**World Forum for Harmonization of Vehicle Regulations****Working Party on Automated/Autonomous and Connected Vehicles****Eleventh session**

**UN Regulation No. 90****Proposal for amendments to UN Regulation No. 90  
(Replacement brake parts)****Submitted by the expert from Italy\***

Figure 1

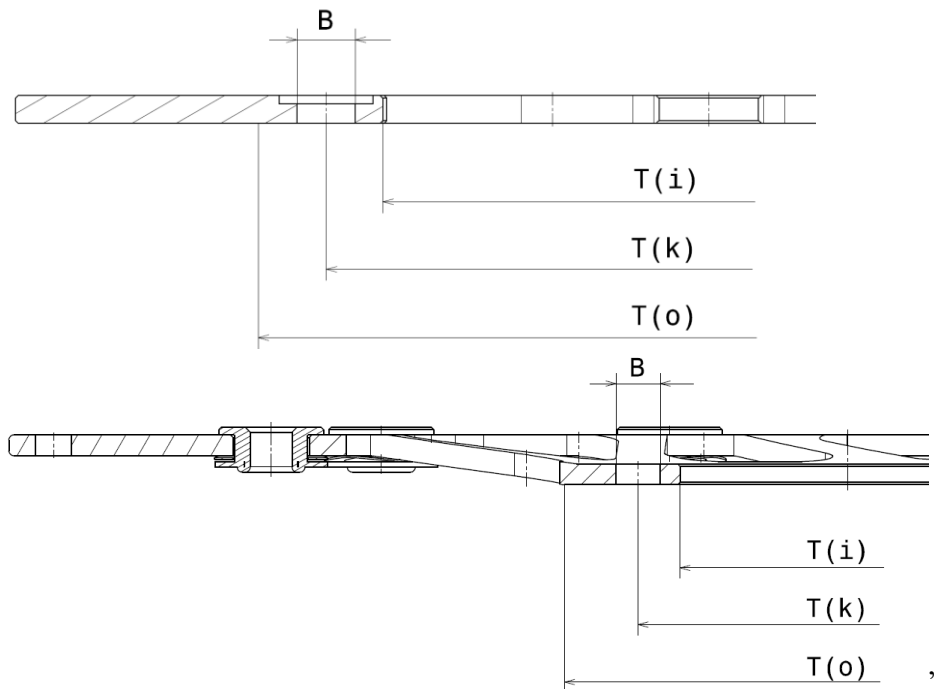
Insert a new paragraph 1.5., to read:

**“1.5. Definition of bell mounting face**

“*Bell mounting face*” means the surface of a brake disc that goes in contact with wheel hub.

The mounting surface is calculated between the disc inner diameter T(i) and a diameter T(o) defined as the max diameter of area subjected to flatness restrictions as indicated on disc drawing (see figure 1).

In case of lacking of drawing indication, T(o) is defined as follows:

$$T(o) = T(k) + B + 10mm$$
